**LEVY NUCLEAR PLANT, UNITS 1 AND 2  
DOCKET NOS. 52-029 AND 52-030**

**RESPONSE TO SUPPLEMENTAL REQUEST FOR ADDITIONAL INFORMATION REGARDING  
THE ENVIRONMENTAL REVIEW**

**Levy Nuclear Plant Units 1 and 2**  
**Response to NRC Supplemental Request for Additional Information Regarding the**  
**Environmental Review for the Combined License Application, dated September 25, 2009**

Figure 9.3-7-1 – Levy 2 / LNP Site Locations

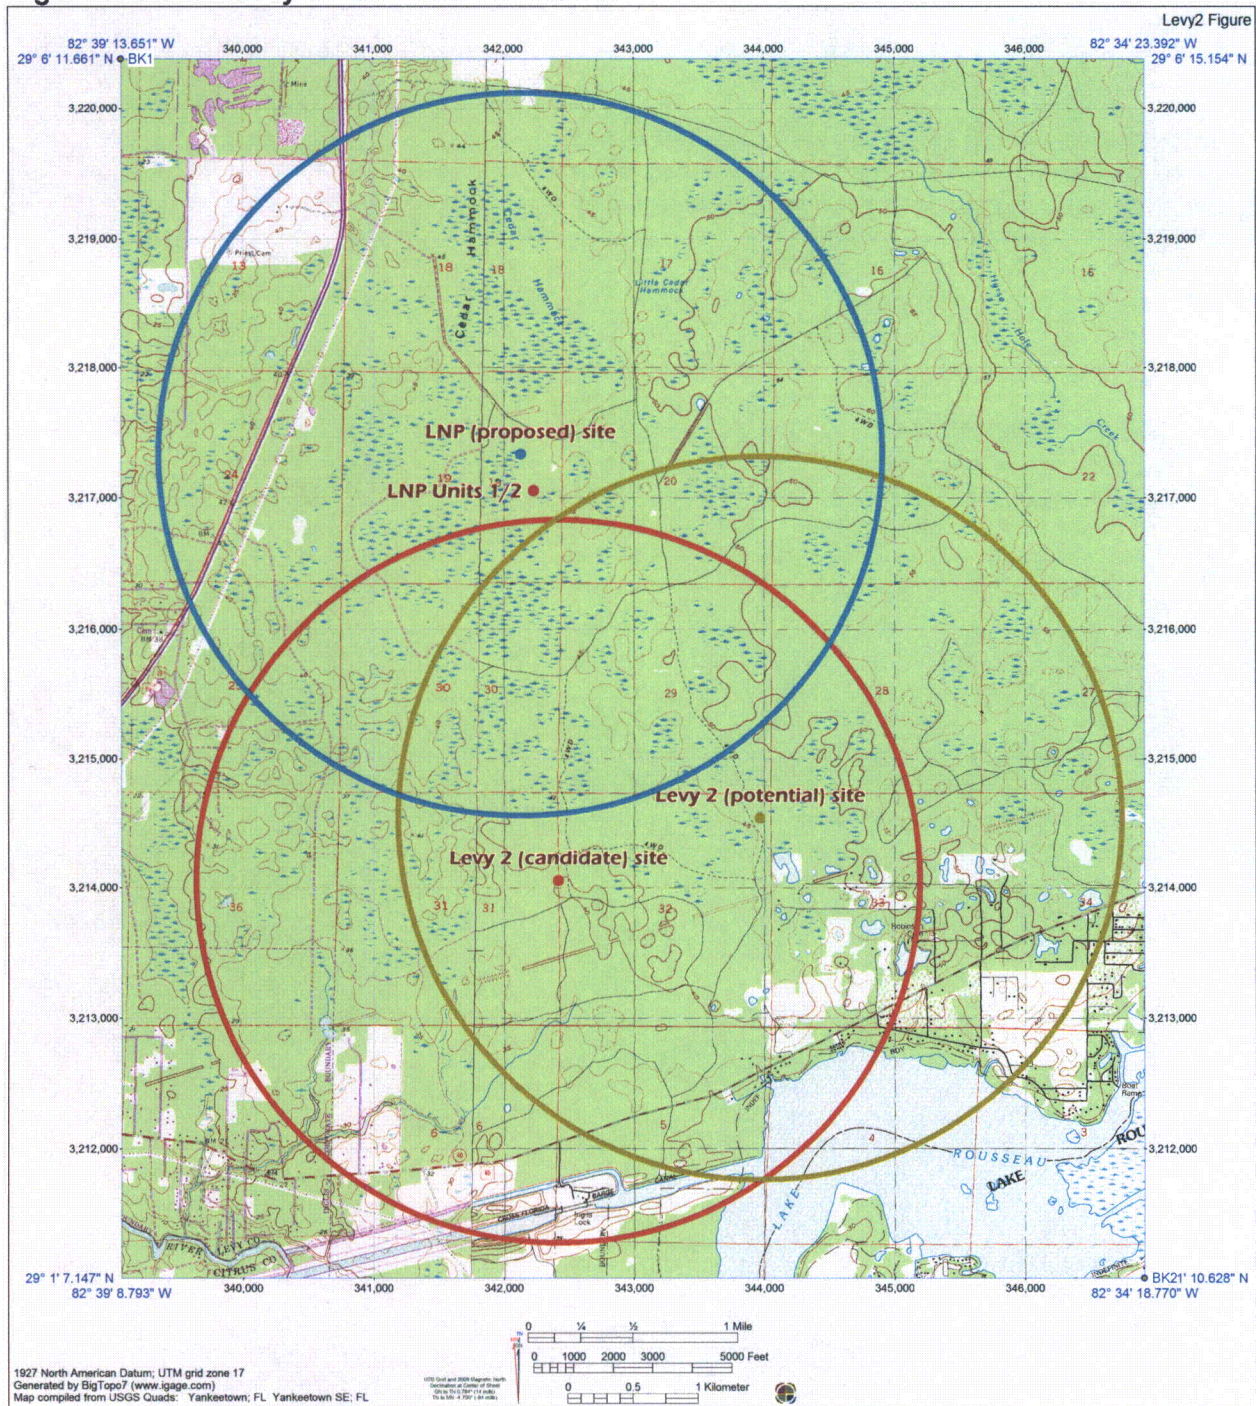
**Text of NRC RAI:** Clarify the boundaries of the Levy 2 site as reported in the EFS and ER.

Aerial photos in the unredacted version of the EFS (Appendix A, page 10 of 22) suggest that the geographical location for the Levy 2 site (i.e., the preferred LNP site analyzed in the ER) is not consistent with the location of the LNP site as presented in the ER. Provide clarification.

The EFS siting process allows for optimization of sites as the process is executed and additional information is gathered. The LNP site was optimized during the siting process. Figure 9.3-7-1 depicts the geographic locations of the Levy 2 potential site, the Levy 2 candidate site, and the LNP site, as the site was slightly relocated to optimize or respond to siting considerations and findings from the analysis at various stages of the process. The Levy 2 (potential) site is the originally selected site (EFS Appendix IV, Section 4.0) as evaluated in the screening criteria evaluation of potential sites (EFS Appendix IV, Section 5.0). The Levy 2 (candidate) site is the relocated site as optimized based on aerial overflights and additional research and is evaluated in the general site criteria evaluation (EFS Section 6.0). The LNP site is the proposed site location as ultimately acquired and analyzed in the ER. The center point of the two LNP units is also depicted on the attached figure. The circles represent the 6,000-acre areas analyzed in the siting study.
